Contract # C-35327
Design-Build Services for Rockaway Line Resiliency and Rehabilitation

Submittal Number: C35327-7FR-0006.00

Description: DU02 - Spray-on Fireproofing Shop Drawings for Signal Tower

LOWER LEVEL FRAMING PLAN

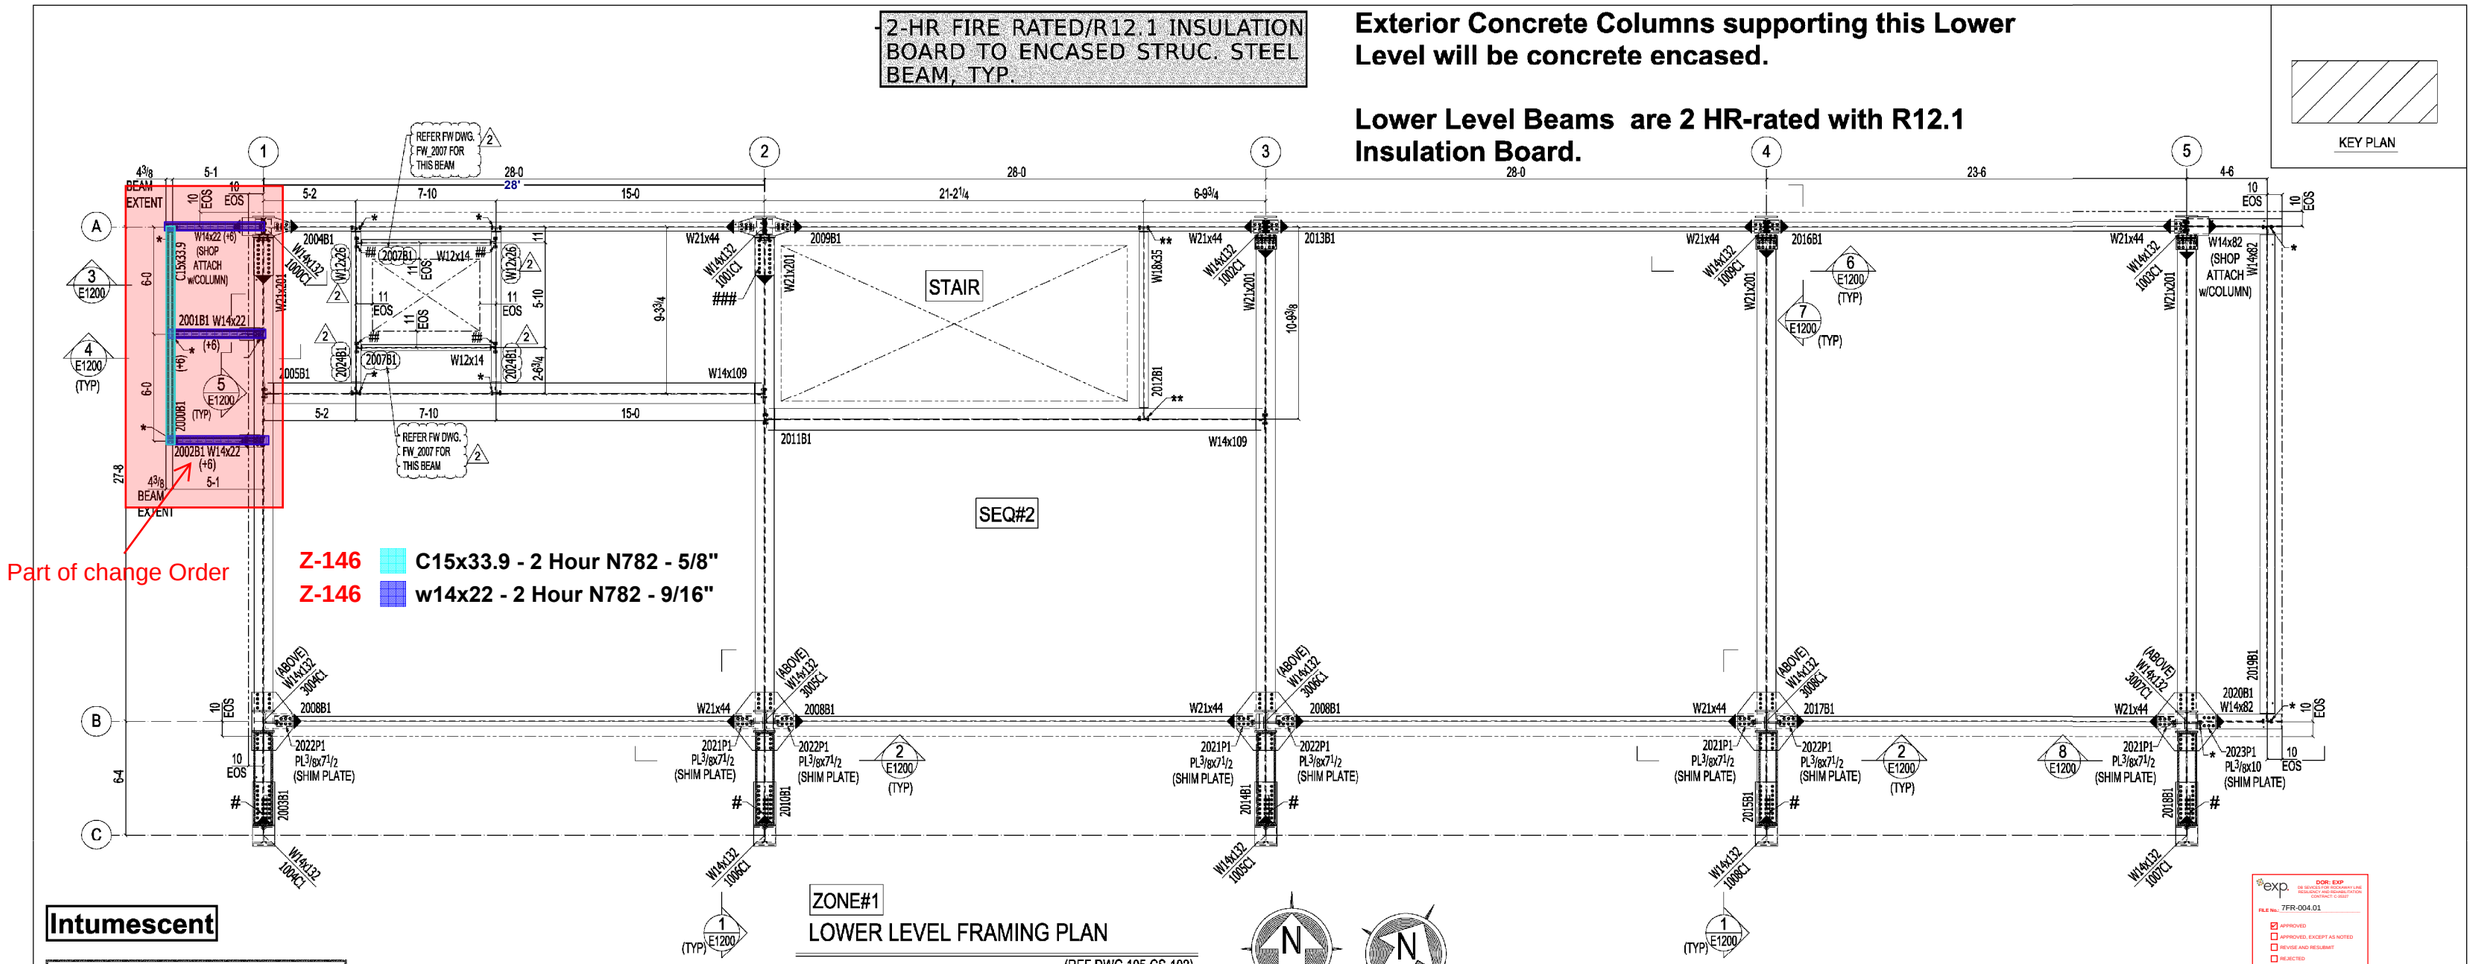
2-HR FIRE RATED/R12.1 INSULATION BOARD TO ENCASED STRUC. STEEL BEAM, TYP.

Exterior Concrete Columns supporting this Lower Level will be concrete encased.

Lower Level Beams are 2 HR-rated with R12.1 Insulation Board.

PLATFORM LEVEL FRAMING PLAN

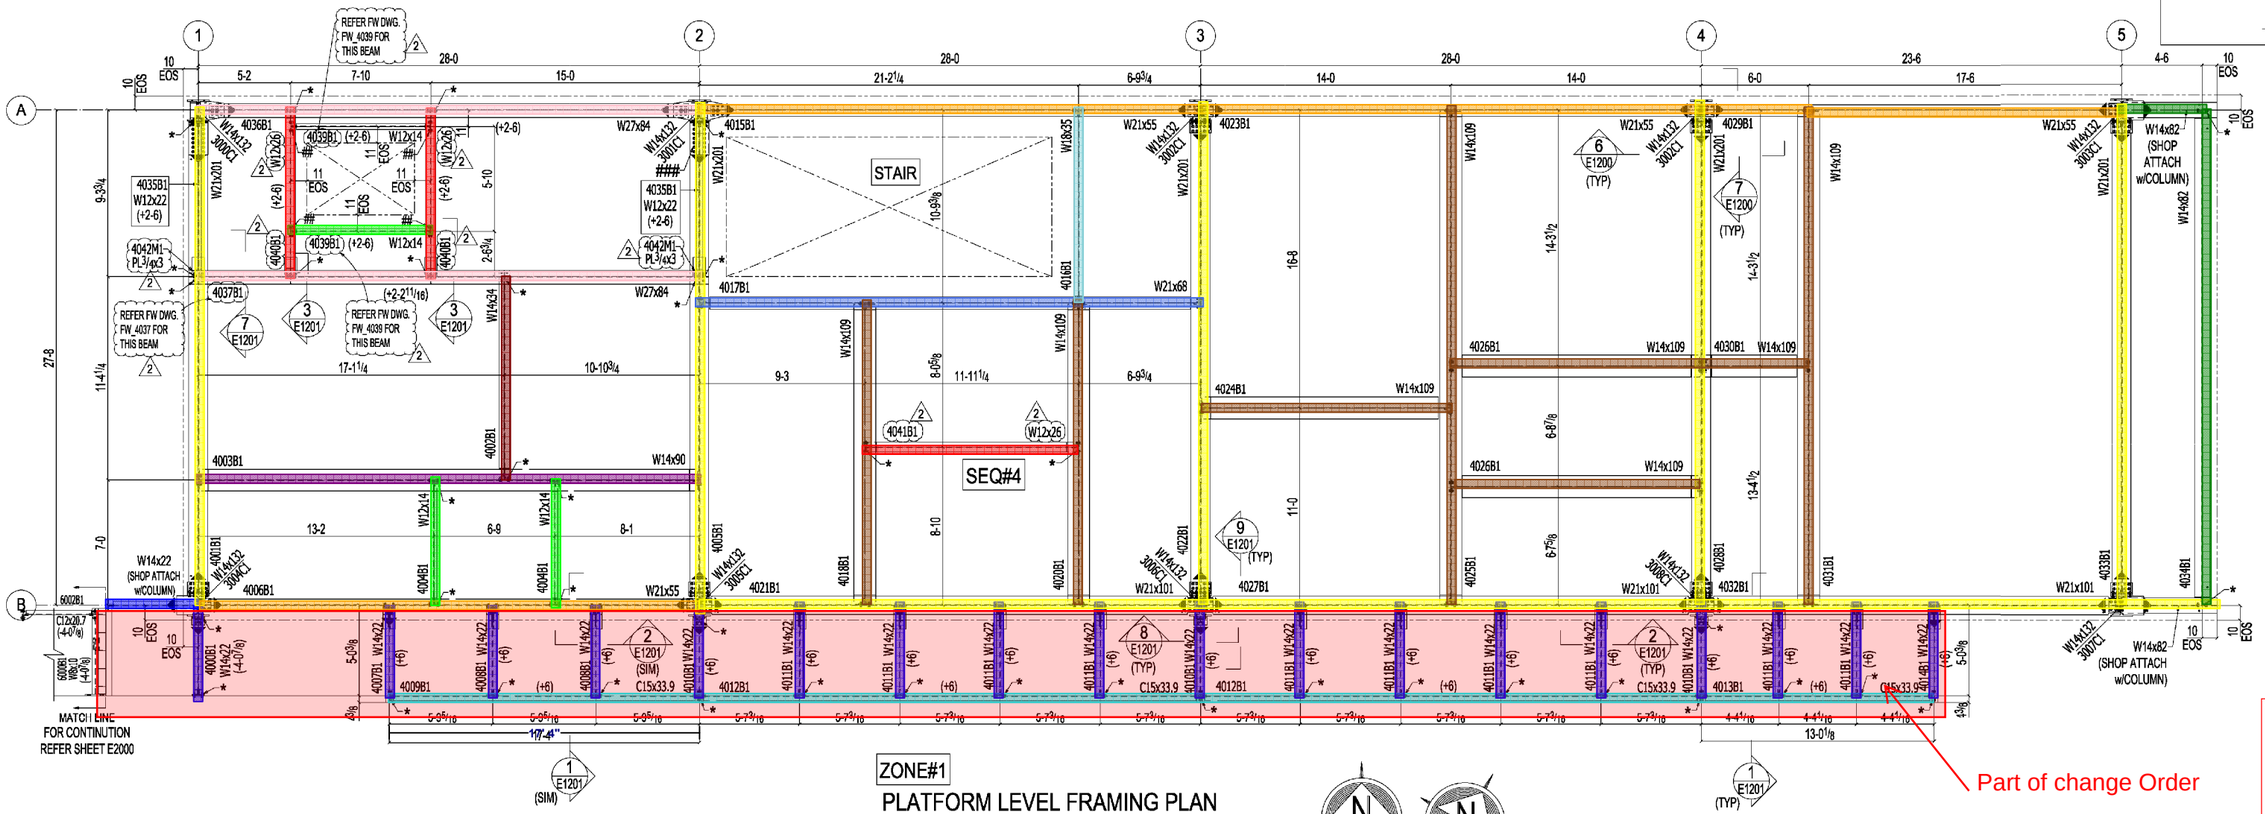
Members W18 and greater to receive metal lath across steel web per UL guidelines. All members to receive Firebond bonding agent Noted 10/22/25.

ROOF LEVEL FRAMING PLAN

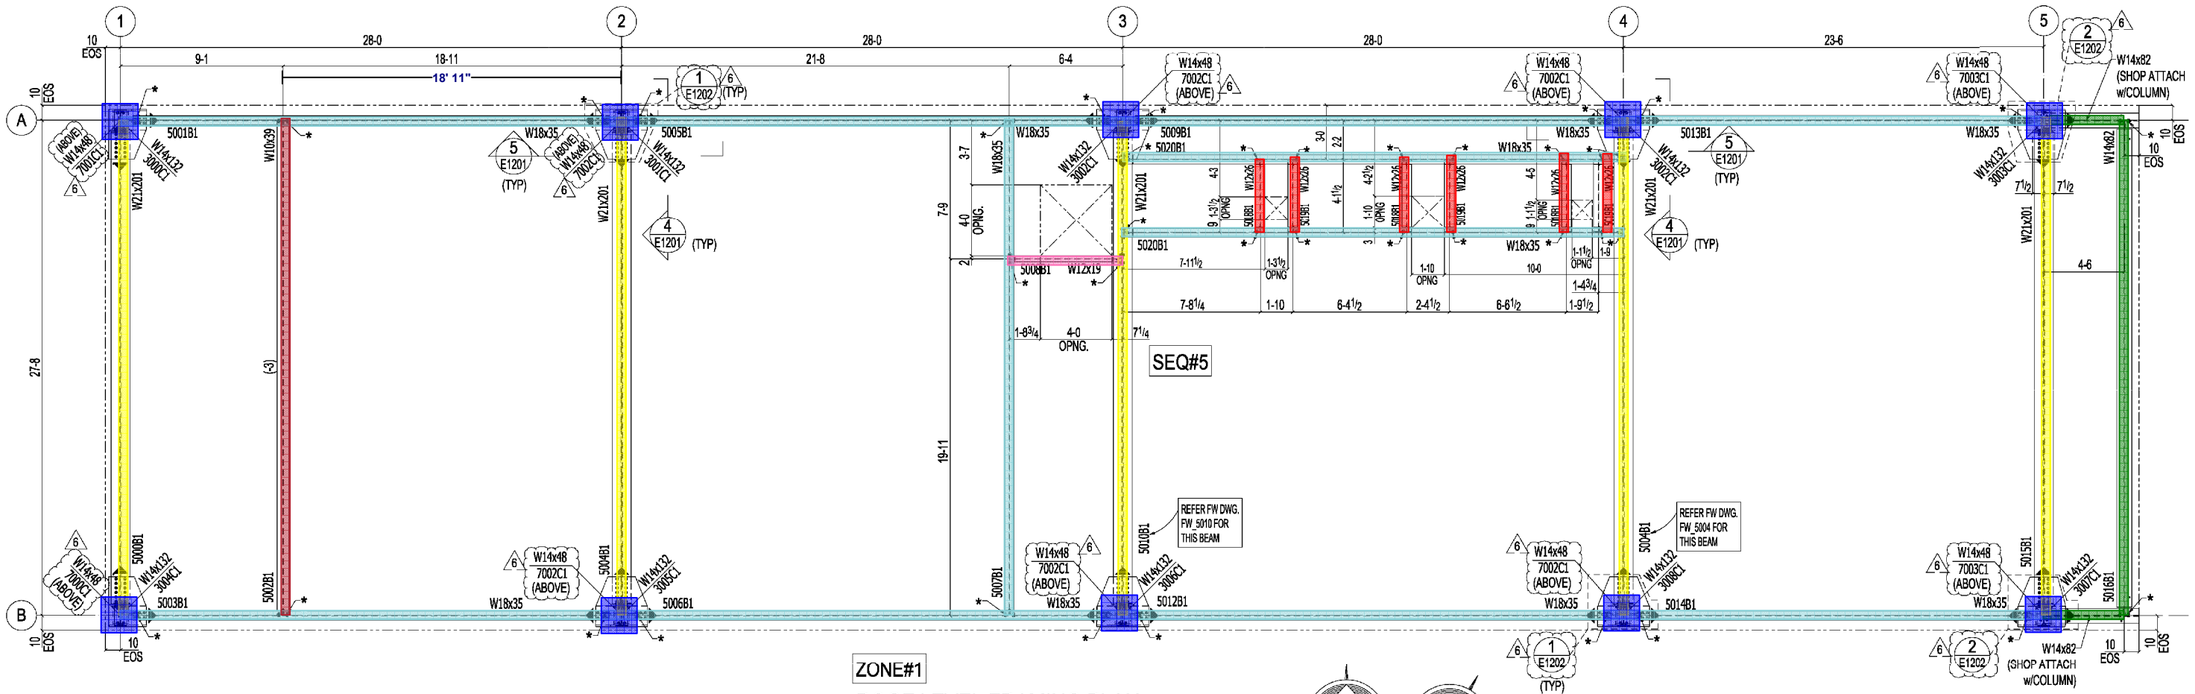
Members W18 and greater to receive metal lath across steel web per UL guidelines. All members to receive Firebond bonding agent Noted 10/22/25.
